Subject: Fuel Leak Case No. RO0000320 and Geotracker Global ID T0600101592, PACO Pumps Inc, 9201 San Leandro Street, Oakland, CA 94603

Alameda County Environmental Health (ACEH) staff has reviewed the fuel leak case file for the above-referenced site including the recently submitted report entitled, "*Work Plan to Conduct Investigation and Remediation Activities at 9201 San Leandro Street, Oakland, California (Fuel Leak Case #RO0000320)*". The *Work Plan*, which was prepared on behalf of Mr. Mark Vignoles, Service West, by LFR Environmental Management & Consulting Engineering, proposes further investigation to define the horizontal and vertical extent of contamination, shallow soil excavation, and a pilot test to evaluate soil vapor extraction and air sparging.

Attachment A: Revised Sample Locations

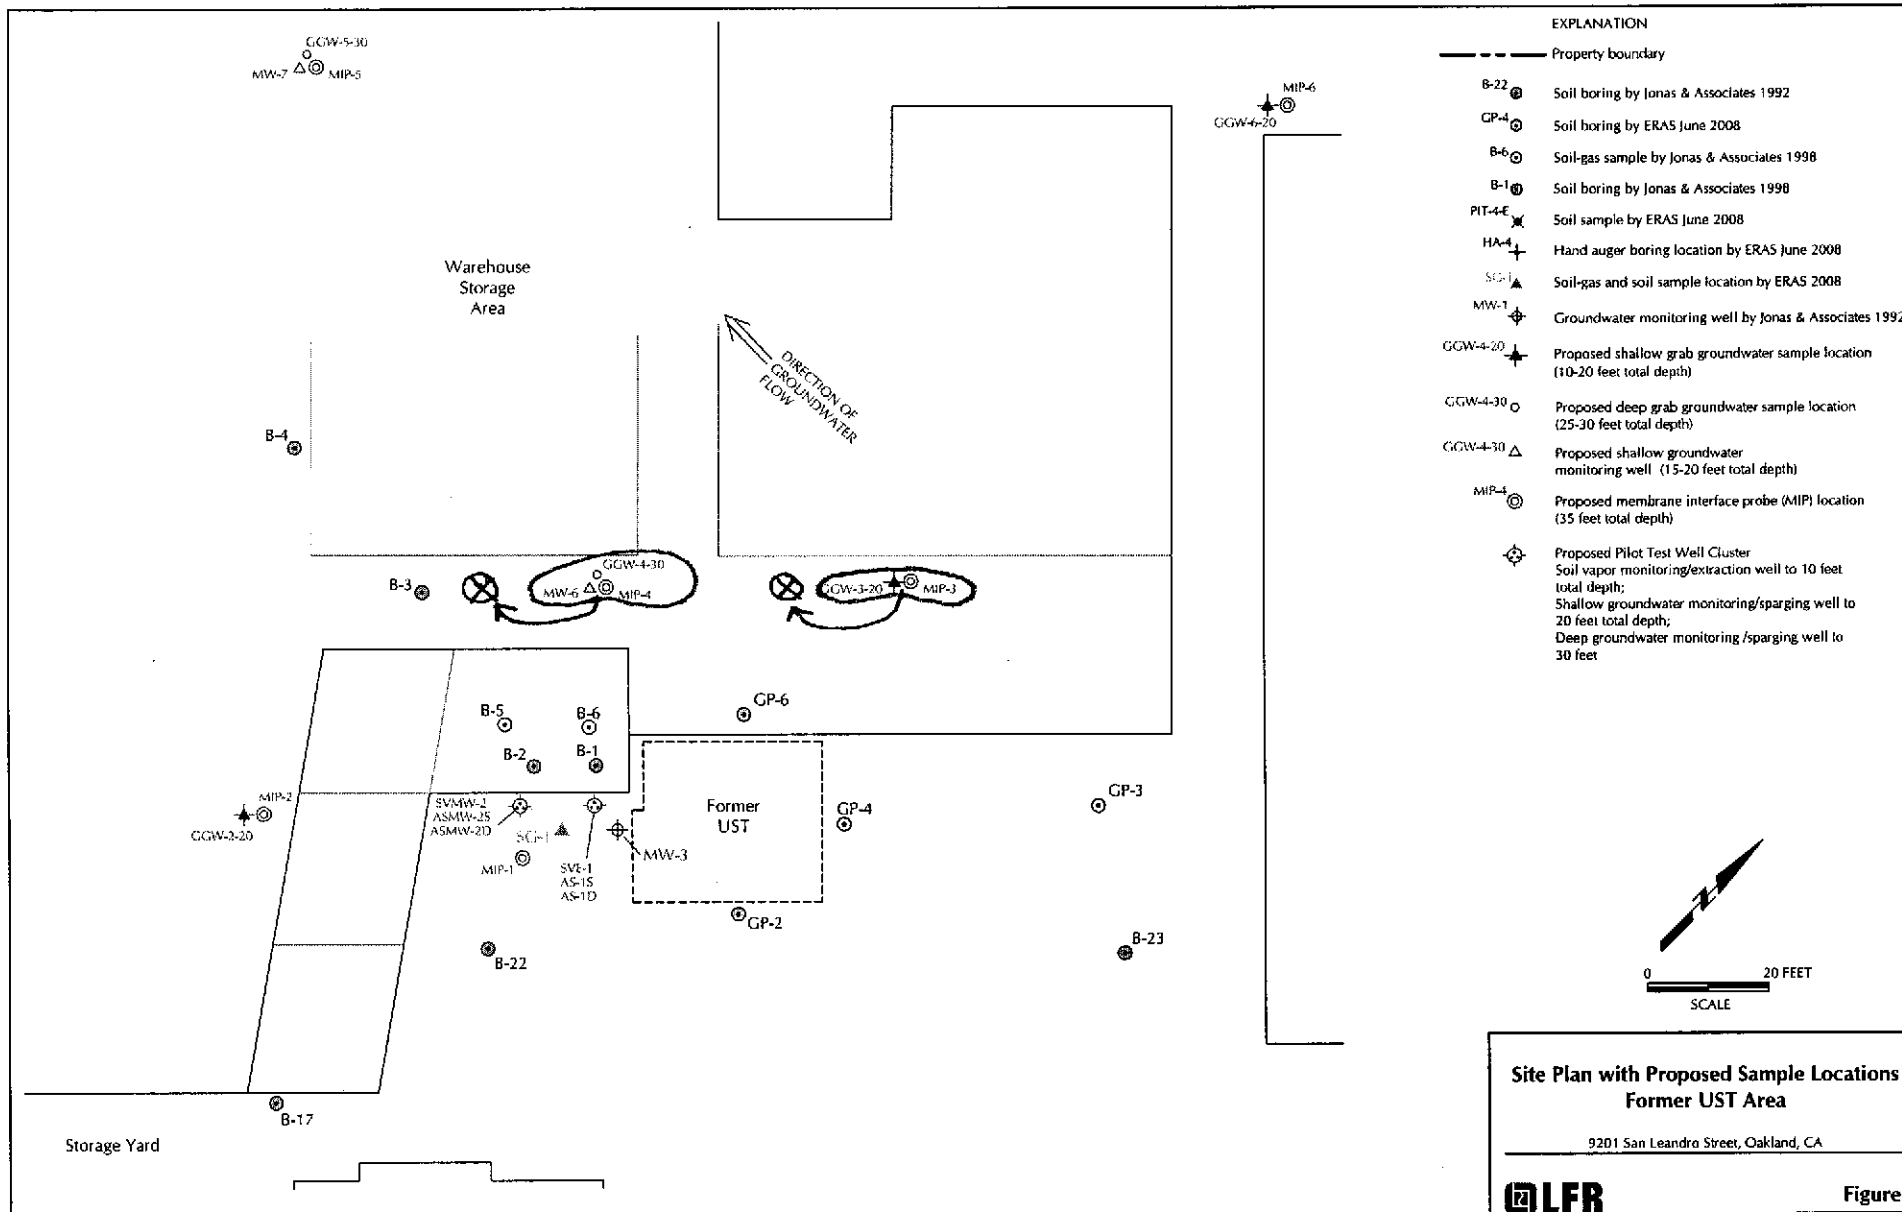
5. **Proposed Locations for MIP Borings.** We request that proposed MIP borings MIP-3 and MIP-4 be moved approximately 15 feet in a southwesterly direction in order to be in locations that are more directly downgradient from the former UST. Please see Attachment A: Revised Sample Locations.
